Subject: Final Rule, Response to Petitions for Reconsideration, Technical Amendment, Docket No. 2008-0111, Anthropomorphic Test Devices; ES-2re Side Impact Crash Test Dummy 50th Percentile Adult Male.

First Technology Safety Systems (FTSS) has reviewed the February, 2008, ES-2re dummy drawing package (identified in the above mentioned technical amendment) and we have identified a number of drawing errors and a number of drawing issues. We seek to petition NHTSA to correct these drawings to ensure that the ES-2re dummy continues to meet the same dimensional and performance requirements established for the dummy when the dummy was proposed for inclusion into 49 CFR Part 572 Subpart U. FTSS makes the following comments and recommendations with respect to the drawing package. A marked up drawing for each of these recommended changes are attached to the end of this letter.

SHOULDER ASSEMBLY

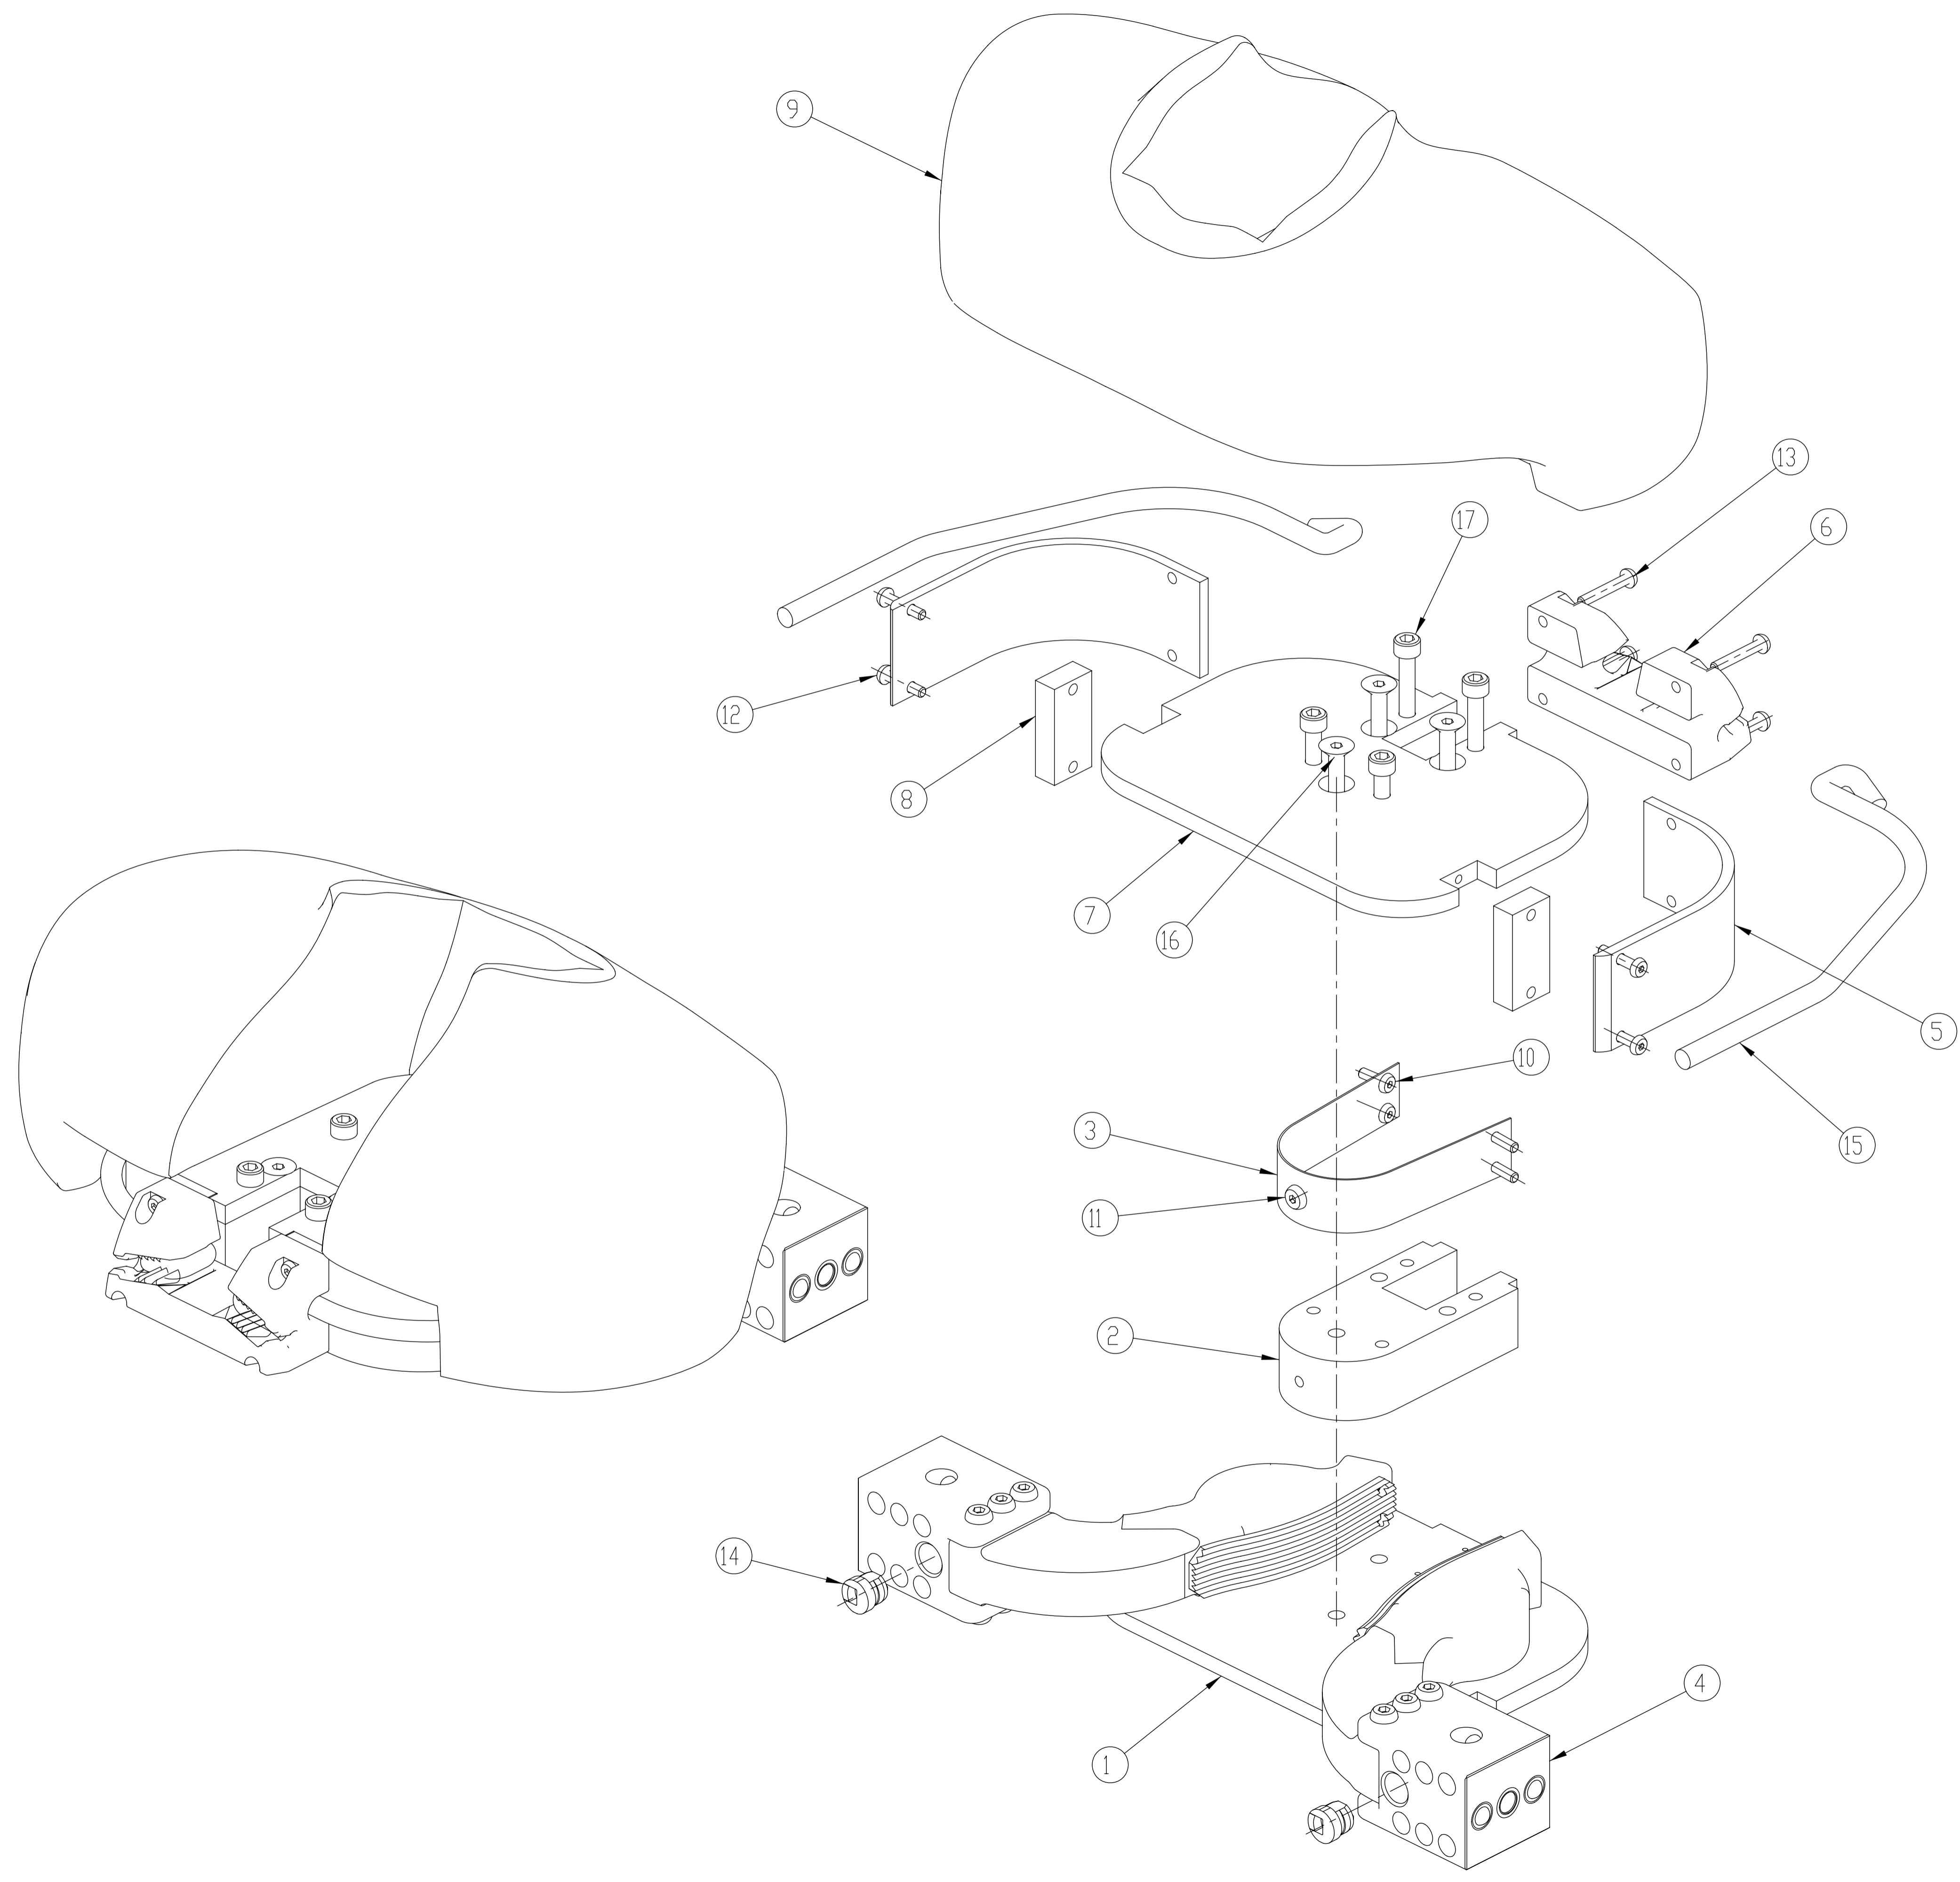
- 10) Drawing 175-3000, Shoulder Assembly. FTSS recommends that NHTSA part number 5000014 SHCS, M6 x 1 x 35, be replaced with part number 5000008 SHCS, M6 x 1 x 30 because the 5000014 SHCS is too long to properly secure the assembled parts. The M6 x 1 x 35 SHCS is supposed to secure the Shoulder Top Plate (175-3008) to the Shoulder Spacer Block (175-3002). However, the Shoulder Top Plate has a material thickness of 8 mm and the Shoulder Spacer Block has a material thickness of 25.5 mm. Together, the overall thickness of the combined parts is 33.5 mm – which is 1.5 mm shallower than the length of the 35 mm long SHCS. This will create a condition where the 35 mm SHCS will not clamp the parts properly. A M6 x 1 x 30 SHCS will provide a 3.5 mm clearance to the bottom of the threaded holes on the Shoulder Spacer Block and is therefore an appropriate fastener for this application.

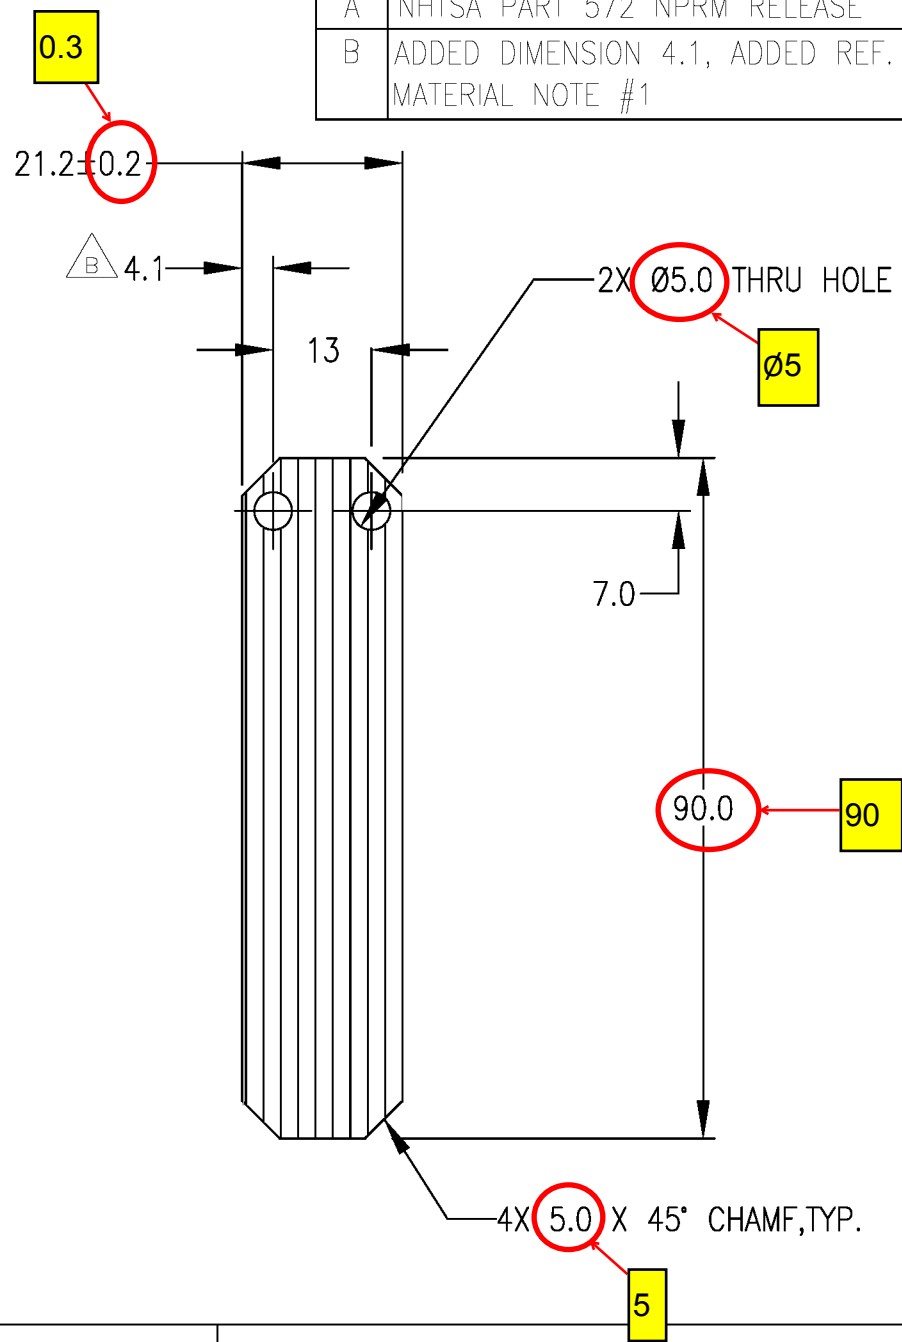
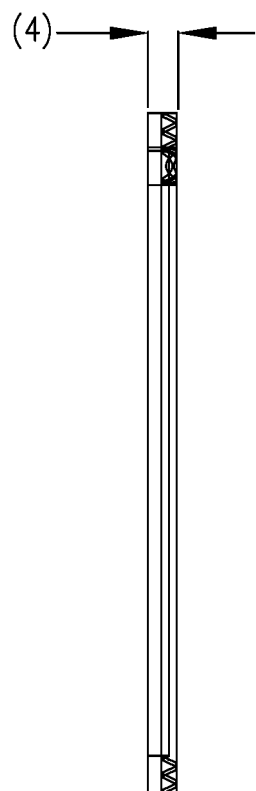
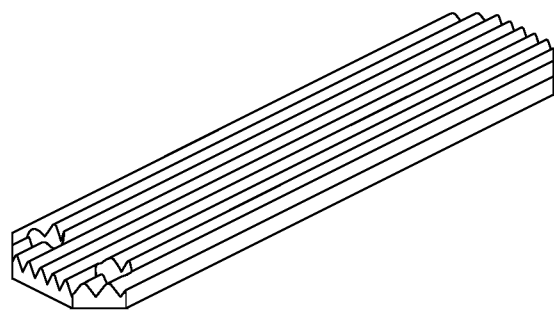
- 11) Drawing 175-3011, CAM Buffer Pad. FTSS has noted that the current dimensions for this part have tolerances that are too tight to accurately control a molded part. We recommend that the NHTSA drawing dimensions: $\text{Ø}5.0$ ", 90.0 ", 5.0 ", and 21.2 ± 0.2 " be replaced with these dimensions: $\text{Ø}5$ ", 90 ", 5 ", 21.2 ± 0.3 ".

ITEM NO.	QTY	PART NO.	DESCRIPTION
PART LIST			
UNITS ARE inches			 NATIONAL HIGHWAY TRAFFIC SAFETY ADMINISTRATION
MATERIAL SEE NOTE #1			
SCALE 1.000			FRICION PLATE RETAINING STUD
APPROVALS		DATE	
DRAWN			SIZE B SHEET 1 OF 1 DRAWING NUMBER 175-7058 REV. B
CHECKED			
ENGINEER

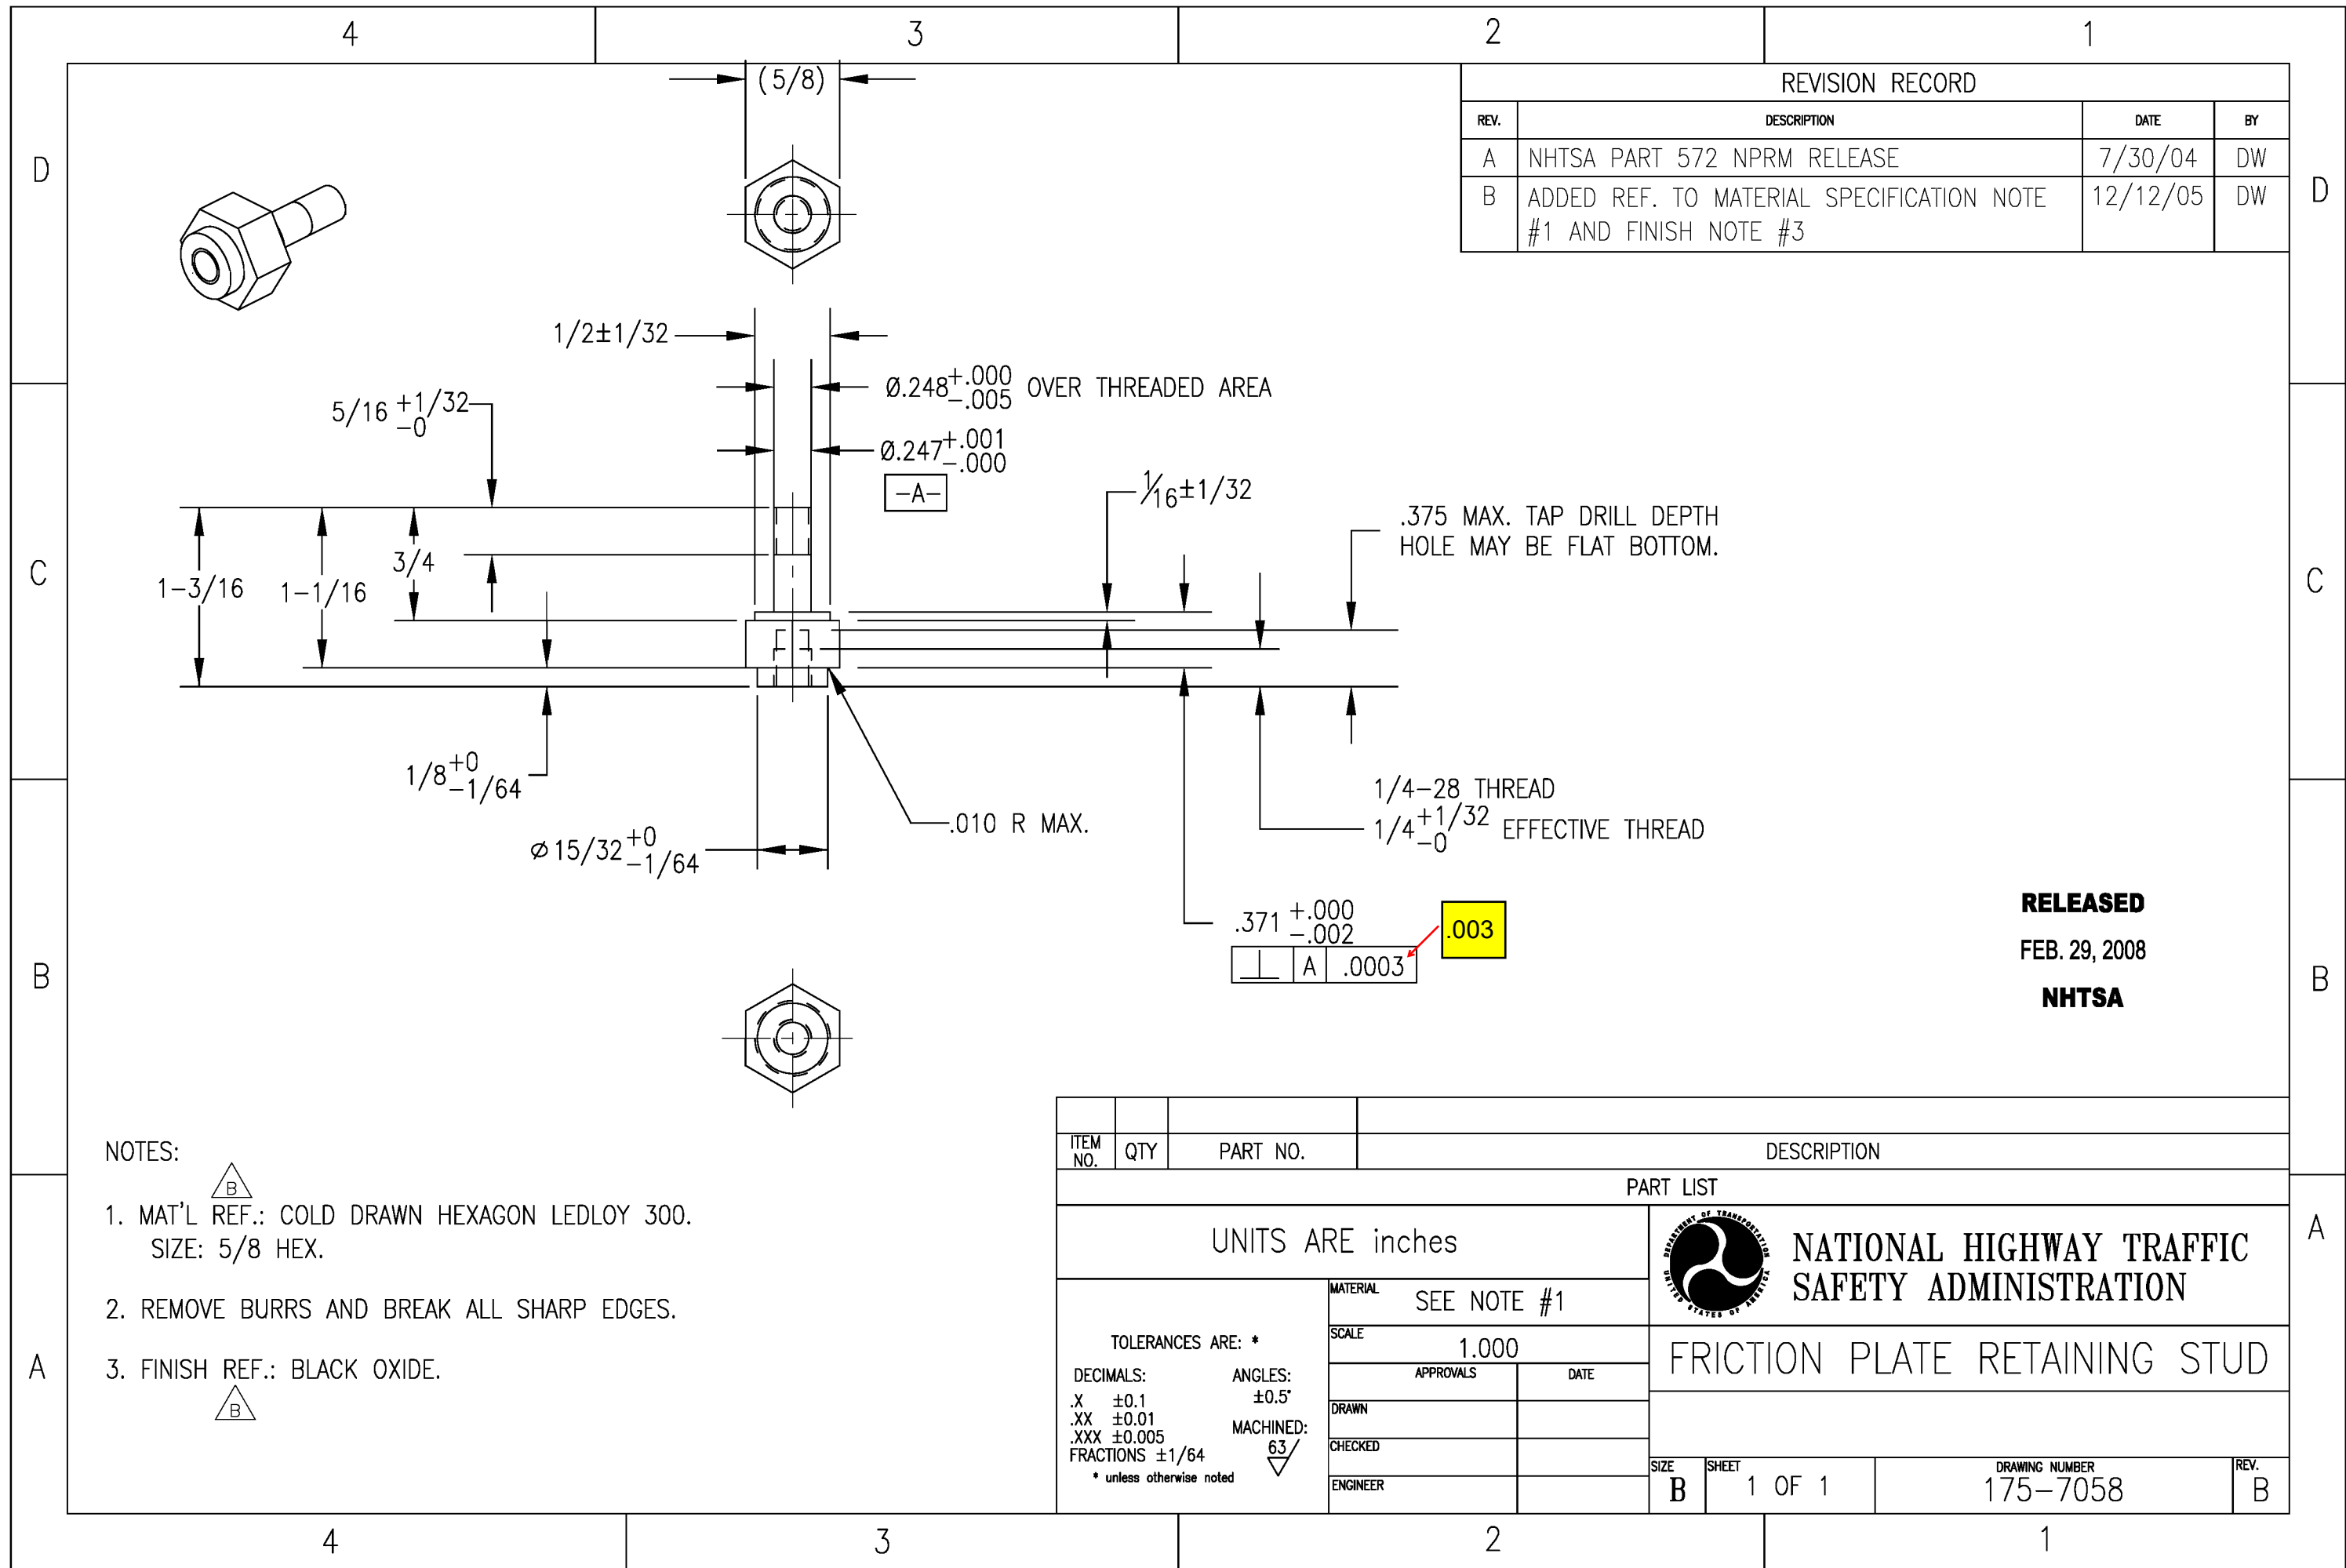
- 12) Drawing 175-7058, Friction Plate Retaining Stud. FTSS believes that the Datum A tolerance of $.0003$ " for the perpendicular surfaces is unnecessarily tight at four decimal places. We recommend a tolerance of $.003$ " because the NHTSA tolerance is too tight to be reasonably measured and therefore accurately controlled. Furthermore, at tolerance of $.0003$ " would add unnecessary cost to the part.
